**DOCUMENT NO:** OP-1903.043

**TITLE:** DUTIES OF THE EMERGENCY  
RADIATION TEAM

**REVISION NO:** 019-00-0

ENTERGY OPERATIONS INCORPORATED  
ARKANSAS NUCLEAR ONE

CONTROL ROOM RADIOLOGICAL MONITORING GUIDELINES

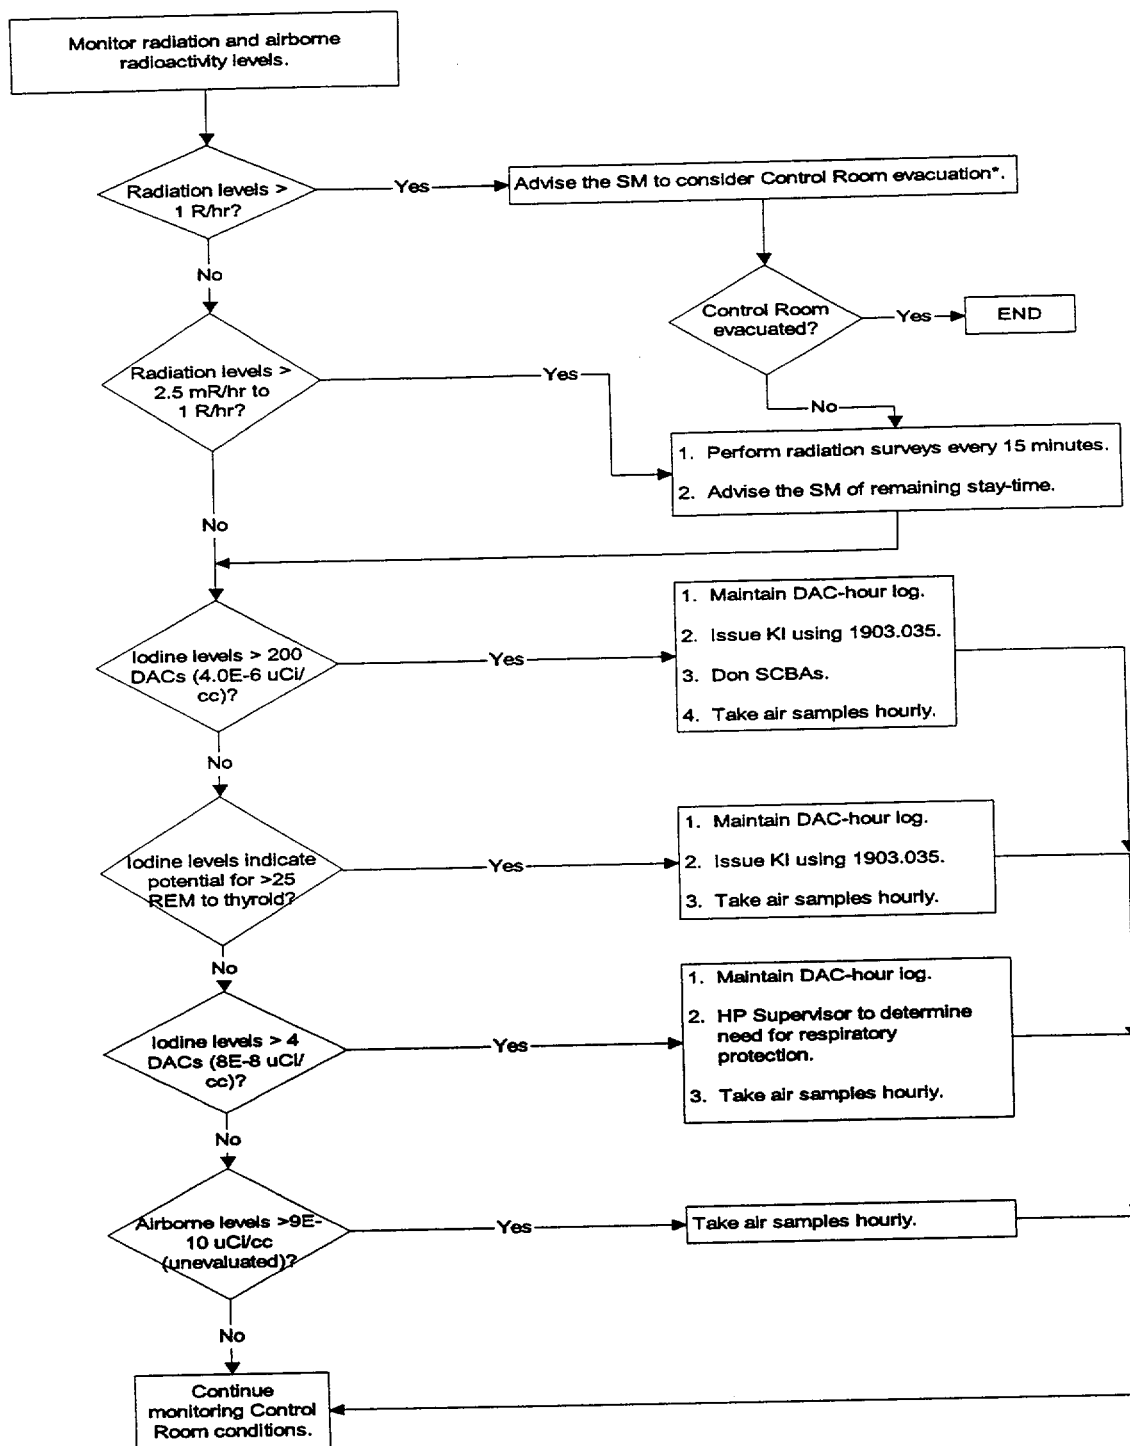
7.7.11	Deleted reference to 1905.032. Procedure no longer exists.		
Attachment 1	Re-formatted flowchart and added action steps for issuance of KI and use of SCBAs.		
FORM TITLE:  DESCRIPTION OF CHANGE		FORM NO. 1000.006C	CHANGE NO. 050-00-0
